To: Members of the Inland Wetlands and Water Courses Commission, Town of Ledward Offe Department

Significant Issues in Opposition to IWWC#25-5SITE - 19, 29 & 39 Military Highway

6" water from Cranberry Pond flooding Harvard Terrace, March 2010 after a heavy rain. In past years on occasion, the water had reached 1' after severe rains.

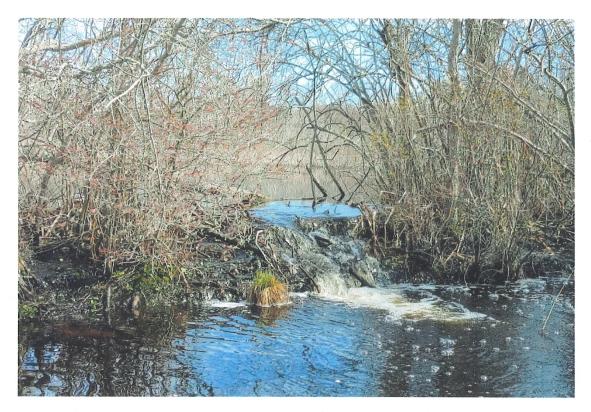
A rough estimate comparing average rainfall in New London County with the water being brought in for use in this complex would suggest that this increased water flow would essentially double the average rainfall on this property. Cole maintained that the wetlands would be "able to detain large quantities of water during storm and flooding events." (p.7) However, earlier this month, there were waterfalls flowing for days over the spit of land from the DEEP wetlands into Cranberry Pond, with less than ½ inch of rainfall the previous week. [See picture] On occasion, we have seen that the town-owned culvert under Harvard Terrace was not adequate for the water flow after heavy rains, and the road was submerged in 6-12" of water. [See picture] We fear that with excess water flow

from upstream, this could happen more frequently, weakening the underlying structure of the road, as well as limiting access to the homes on the street.
